MINUTES OF THE MEETING March 20, 2008

Seattle Design Commission

Urban Mobility Plan
Fire Station 35 – Crown Hill
Fire Station 30 – Mount Baker
Councilmember Richard Conlin
Capitol Hill Station ST University Link

Figure 2: Moving Forward Projects

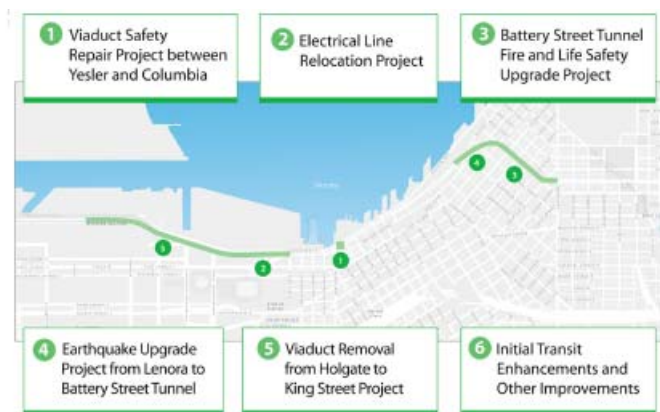
- Commission is familiar with the south end, and recognizes the central waterfront is the key element. Questions will focus on schedule and timing.
- Is the seawall included in the plan?
 - o Yes, each alternative will provide a solution for the seawall.
- How to bring this to the commission in the future, would love to advise you in SR 99, as well as surface street alternatives.
- Appreciate King County being here.
- Appreciate work considering the large challenge and for looking at the entire network for solutions.
- Appreciate the organization of the approach, and how the process will play out given all of the players.
- Regional context is important: Seattle, Tacoma, and Everett. The corridor demand is constantly changing.

Figure 7: Art piece

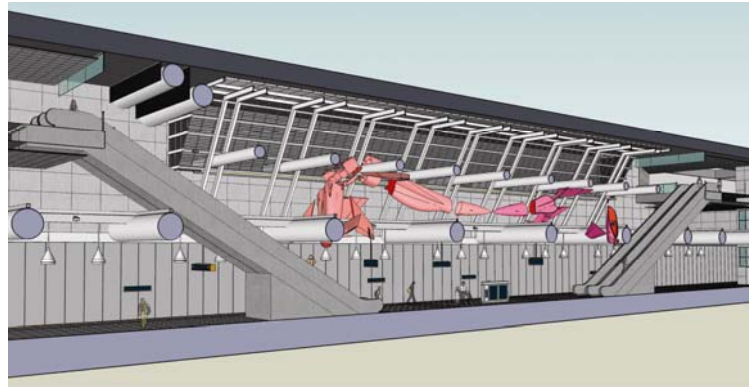
- The materials palette seems reserved and somewhat institutional and may benefit from a more dynamic color scheme.
- Some panel members expressed a concern for the use of warplanes in art piece in the context of a light rail station. While we appreciate the artist's intention of expressing fluid movement and natural forms, the relationship between natural form and a fighter plane as presented is questionable. A solution may be an artist statement prepared for the next presentation to clarify the appropriateness of the art in the station.

- Other ways planes penetrate architecture that is not so offensive?
 - Urge great care in emphasizing poetry of forms in people's minds. Notion of destruction is there in the fighter jets, but the entire form after deconstruction of the pieces is holistic. The piece is not meant to convey aggression.

- Chosen a provocative art piece. Planes may be appropriate with everything that is going on in area and the neighborhood.
- Concern over violent ramifications of art piece. Appreciate that the art seeks to connect important "Seattle qualities" of nature and technology into this piece, but question the use of a fighter jet as the manifestation of those ideas. Encourage further reflection on this, and preparation of an artist's statement for review next time.
